# CONSTRUCTION PLANS FOR THE HILLS AT LORSON RANCH FILING NO. 2

## STREET & STORM SEWER CONSTRUCTION PLANS

**THE RIDGE AT LORSON RANCH FIL NO. 2  
STREET & STORM SEWER  
CONSTRUCTION PLANS**

SHEET NUMBER  
C0.1

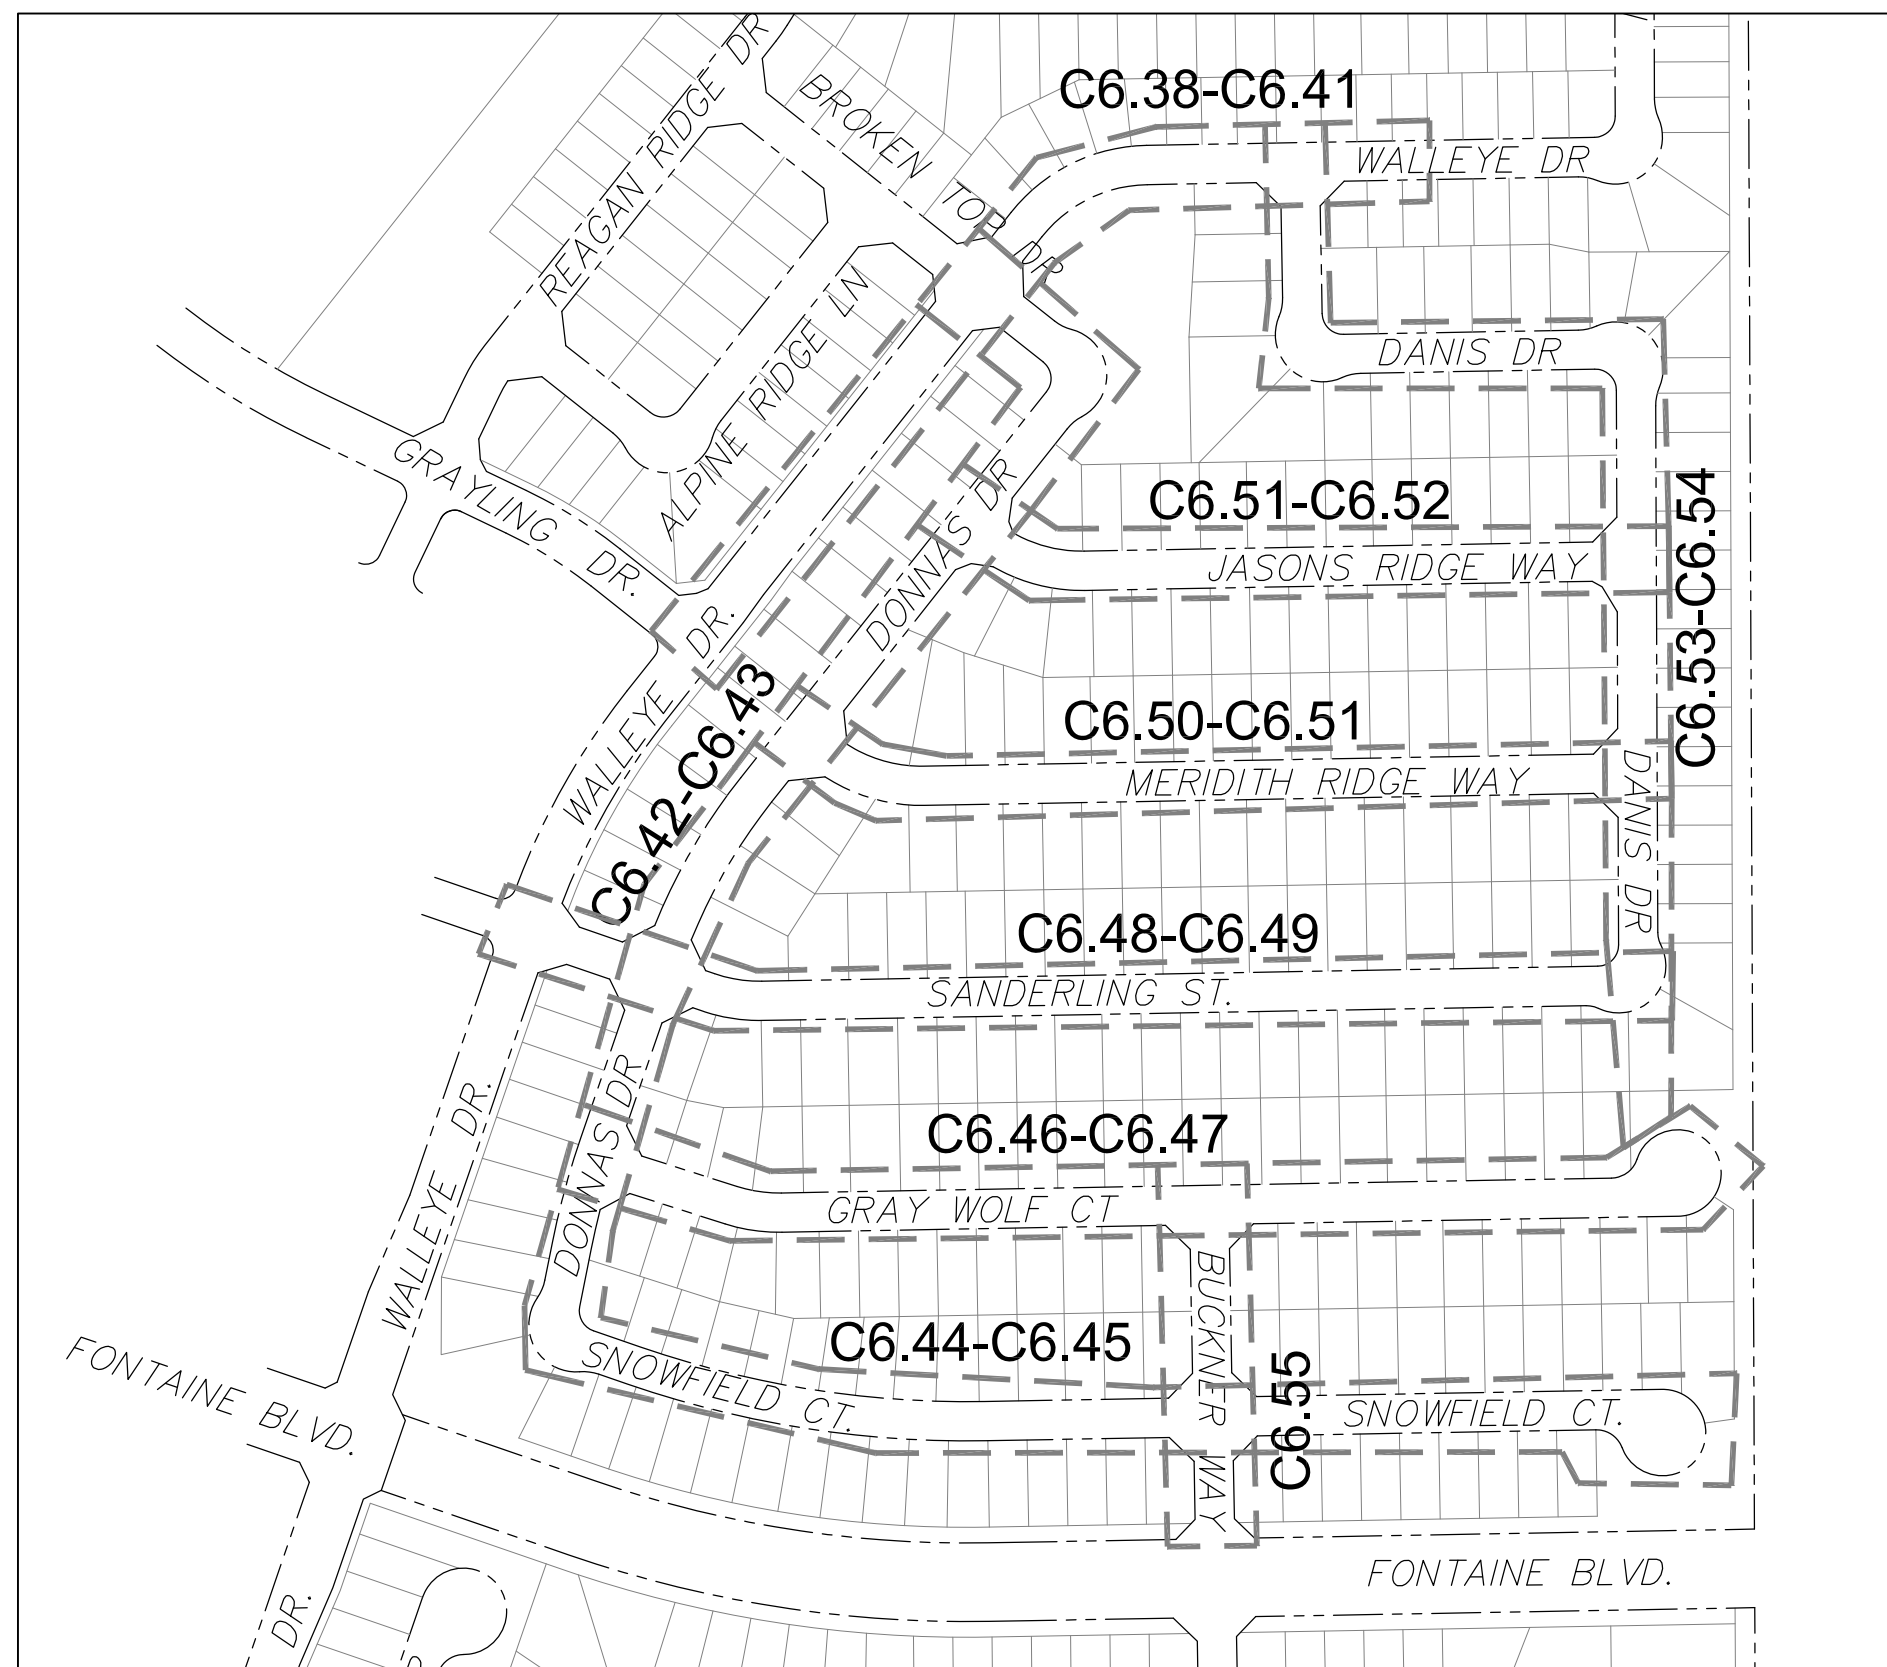
Doesn't match sheet #

DATE: NOV, 2021  
 PROJECT NO. 100.067  
 SHEET NUMBER C5.1  
 TOTAL SHEETS: 28

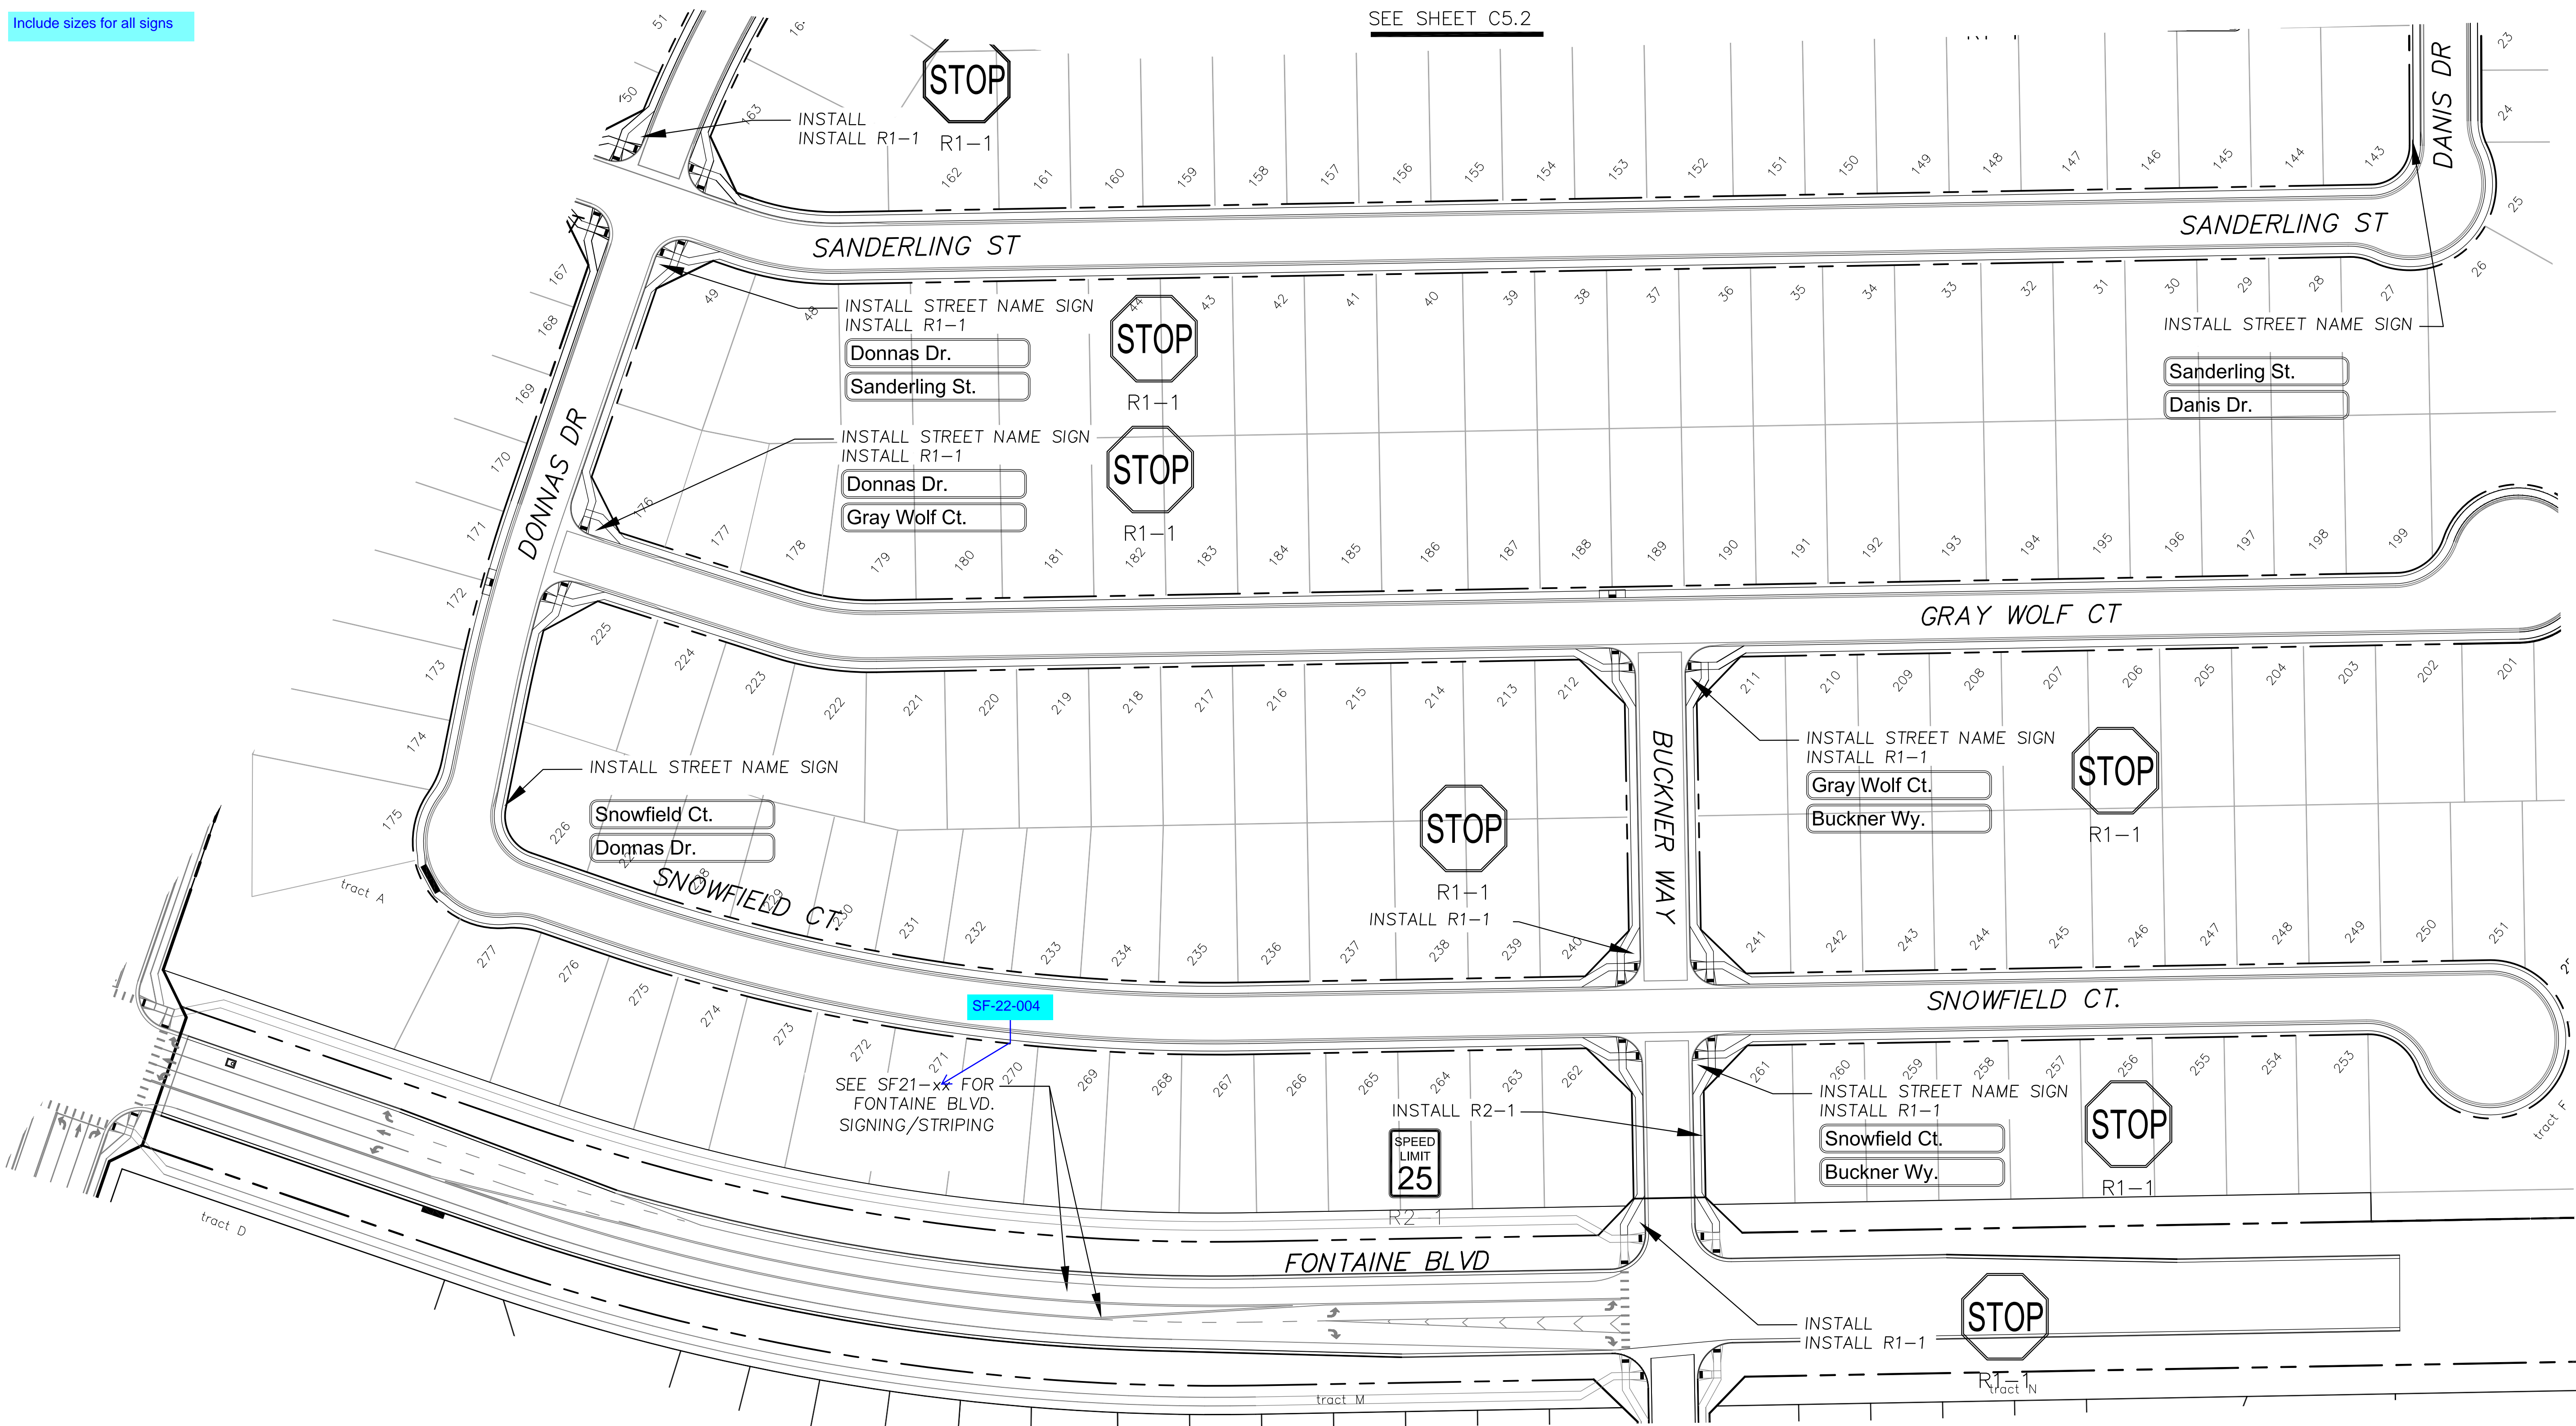
Include sizes for all signs

DATE:  
 NOV, 2021  
 PROJECT NO.  
 100.067  
 SHEET NUMBER  
 C6.39  
 TOTAL SHEETS: 28

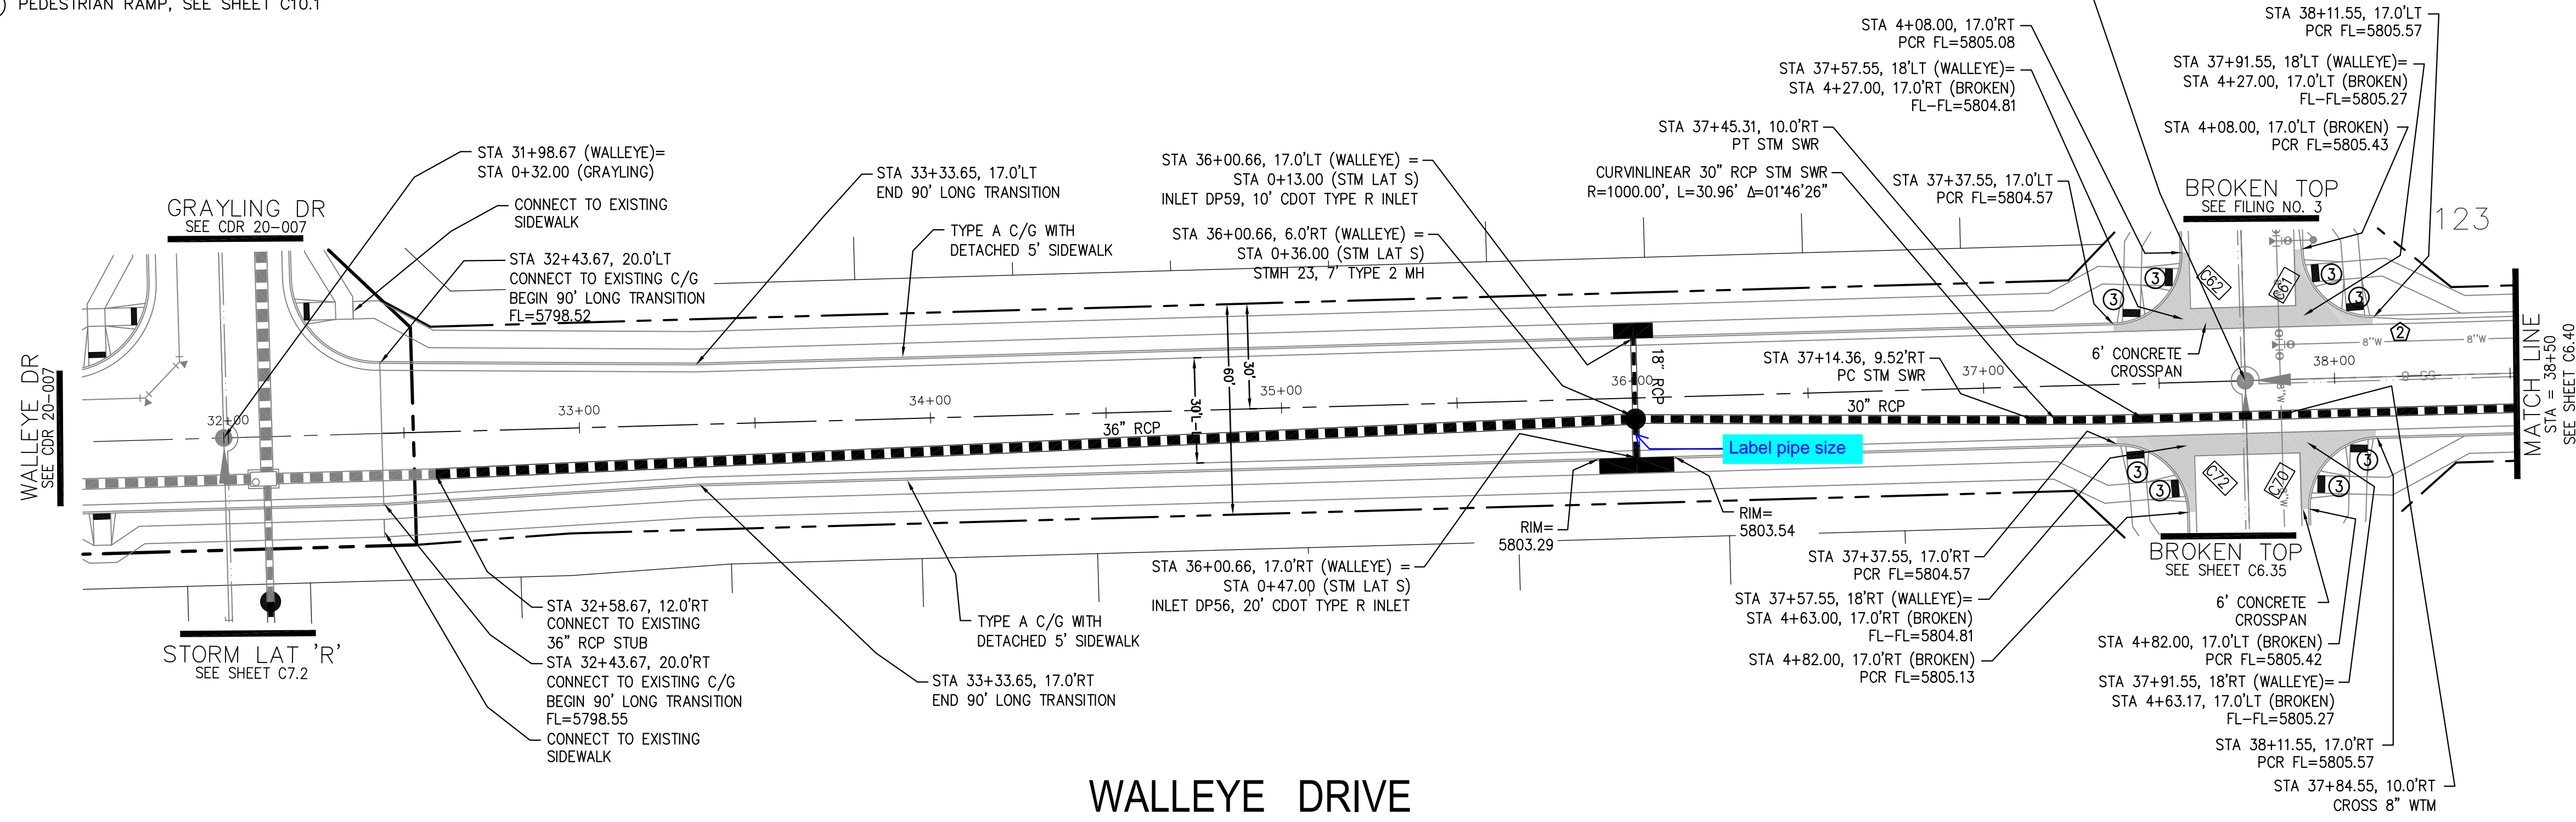
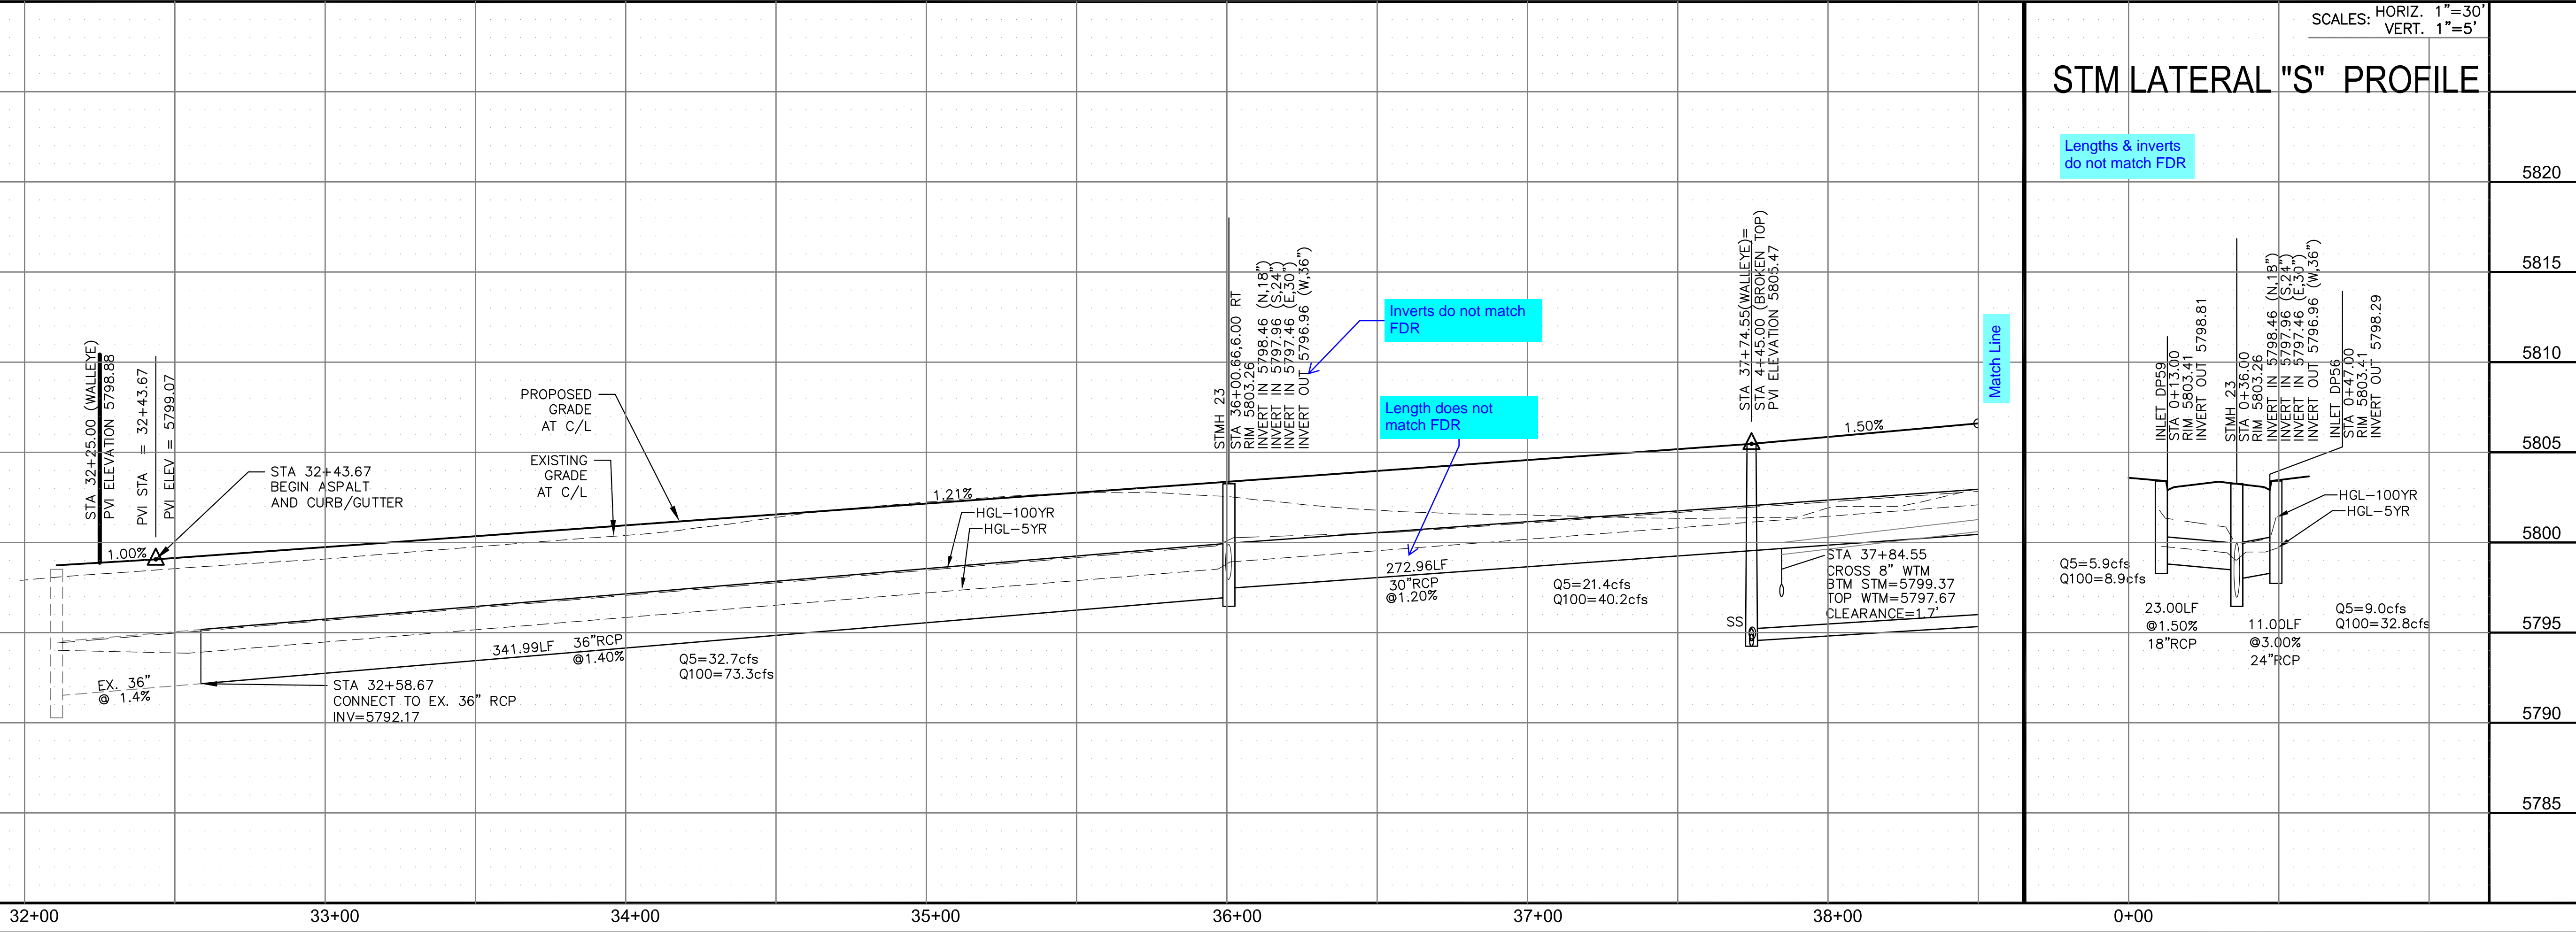
Show all lot numbers.

Label all storm facilities at private or public (all sheets)

Need to include sheet C6.35 to show portion of Broken Top which is within Filing 2.

Lengths & inverts do not match FDR

Inverts do not match FDR

Length does not match FDR
